From: [REDACTED]
Sent: 23/09/2024 10:01:32 AM
To: Council Northernbeaches Mailbox
Subject: TRIMMED: DA 2024/1091; 1 CAREEL HEAD ROAD, AVALON BEACH
NSW 2107 WRITTEN SUBMISSION: LETTER OF OBJECTION
SUBMISSION: TULLOCH
Attachments: 1 CAREEL HEAD WS.pdf;

DA OBJECTION

RE: DA 2024/1091
1 CAREEL HEAD ROAD, AVALON BEACH NSW 2107
WRITTEN SUBMISSION: LETTER OF OBJECTION
SUBMISSION: TULLOCH

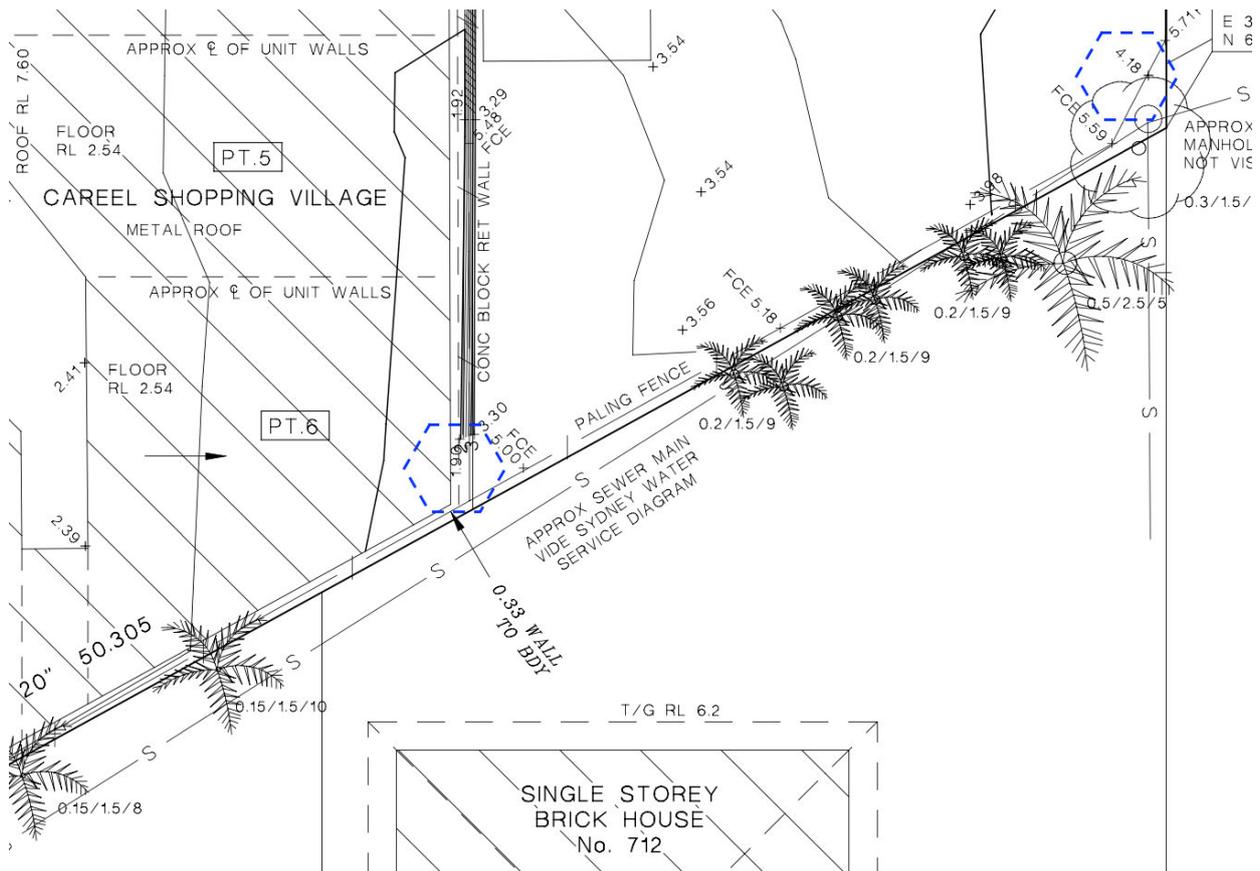
- Excessive Building Height [HOB]: Proposed 9.2m v Control 8.5m [8% non-compliance]
- Excessive Wall Height 8.8m
- Nil setbacks to neighbours' boundaries

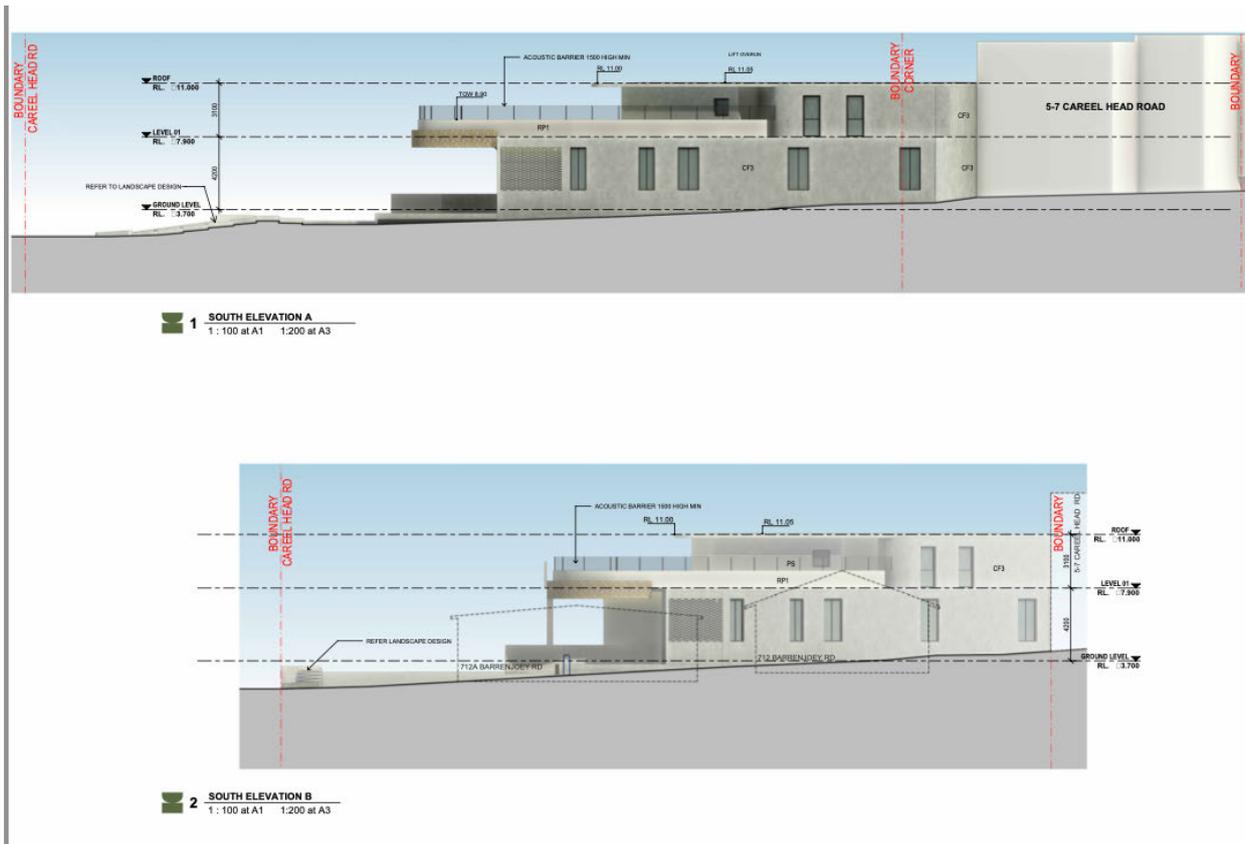
The bulk and scale of the proposed development is inappropriate for the site and locality.

Strict compliance with the maximum building height is reasonable and necessary in the circumstances of this case.

Pittwater Spotted Gum Forest Endangered Ecological Community

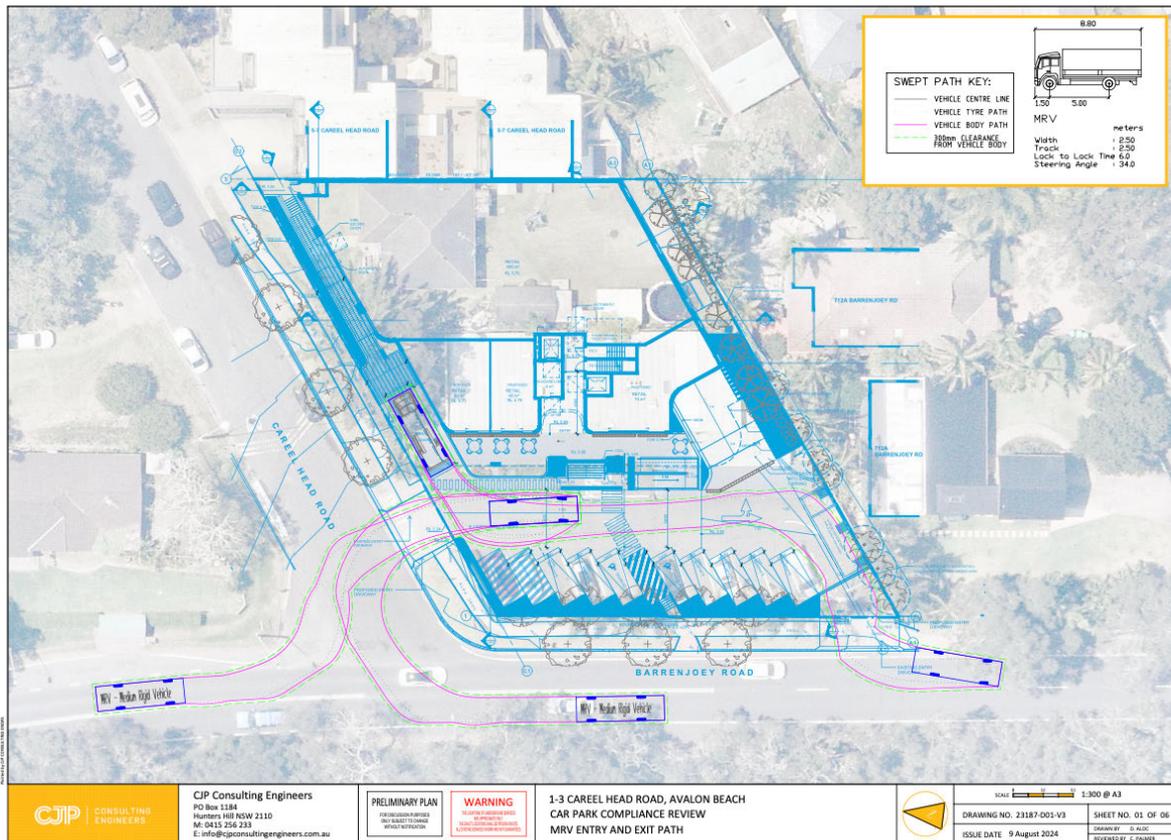
- Deletion of the majority of plant species as they are not characteristic of the Pittwater Spotted Gum endangered ecological community, including any native cultivars.
- Replacement with species to ensure that at least 80% of any new planting incorporates native vegetation (as per species listed for the Pittwater Spotted Gum Endangered Ecological Community)
- Provision of four additional native replacement trees including one each of *Eucalyptus crebra* (Narrow leaved Ironbark), *Golchidion ferdinandi* (Cheese Tree), *Corymbia maculata* (Spotted Gum), and *Allocasuarina torulosa* (Forest Sheoak).

MRV Entry & Exit

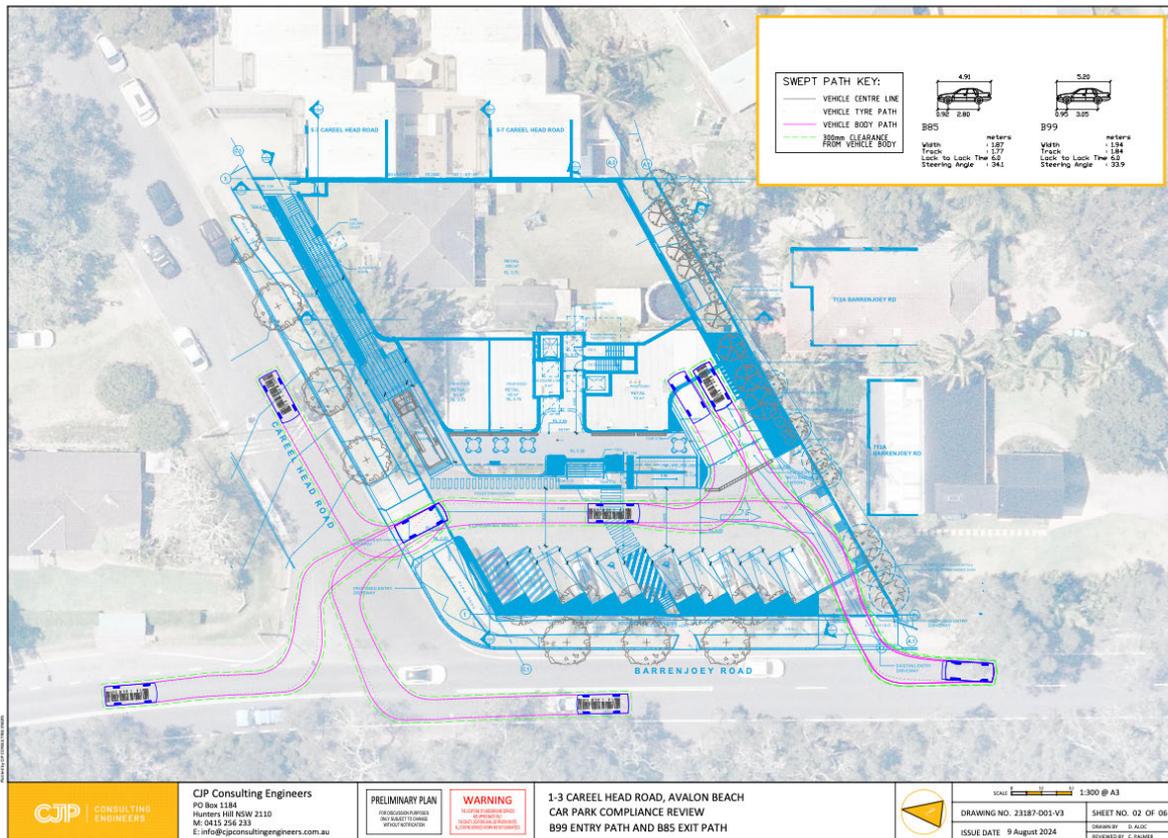
- Would be blocked if traffic queues on Careel Bay Road exiting onto Barrenjoey Road, forcing the MRV to block east bound traffic on Careel Bay Road, causing Barrenjoey Road to be blocked;

- Requires the MRV to reverse against the incoming cars, and across the parked cars at angled parking
- Reverses across a pedestrian crossing from Careel Bay Road

- Adequate Queuing Analysis not provided to prevent vehicle encounters on the entry

Car Park entry from Careel Bay Road

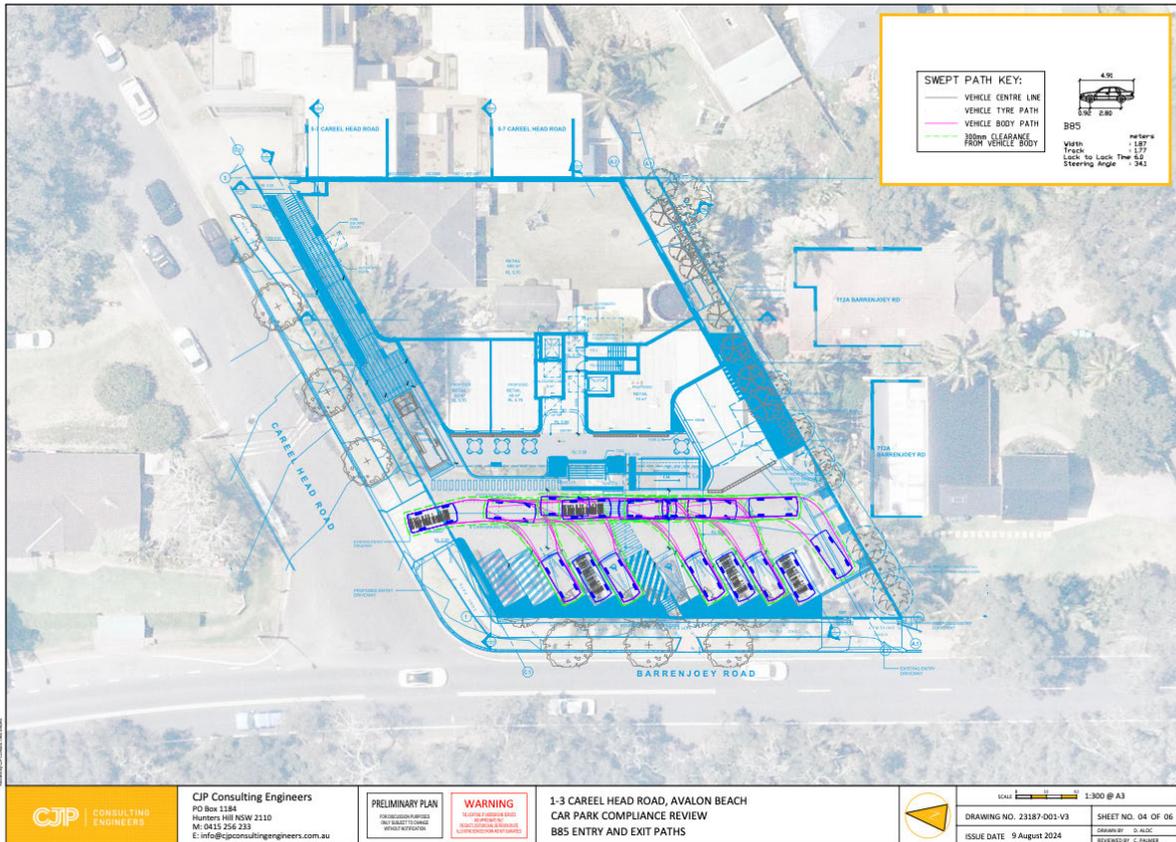
- Would be blocked if traffic queues on Careel Bay Road, forcing the entering cars to block east bound traffic, causing Barrenjoey Road to be blocked;

- Cars parked at splayed spaces requires reversing across a pedestrian crossing form Barrenjoey Road
- MRV exit requires a significant widening of the crossing to Barrenjoey Road
